AMENDMENT 1

Utility connections in port – **PREVIEW**
Part 1: High voltage shore connection (HVSC) systems – General requirements
(standards.iteh.ai)

IEC/IEEE 80005-1

Edition 2.0 2022-02

Figure C.4 – Three-phase ship connector and ship inlet contact assignment

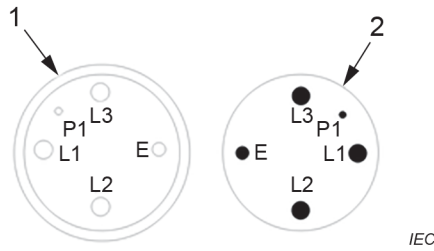
Replace the existing figure and key with the following new figure, key and note:

- 1 Ship connector face
- 2 Ship inlet face
- E Earth
- P1 Pilot line 1 (used for continuity check)
- L1 Phase A – phase R
- L2 Phase B – phase S
- L3 Phase C – phase T

NOTE Pins are showed as solid circles and sockets as open circles.
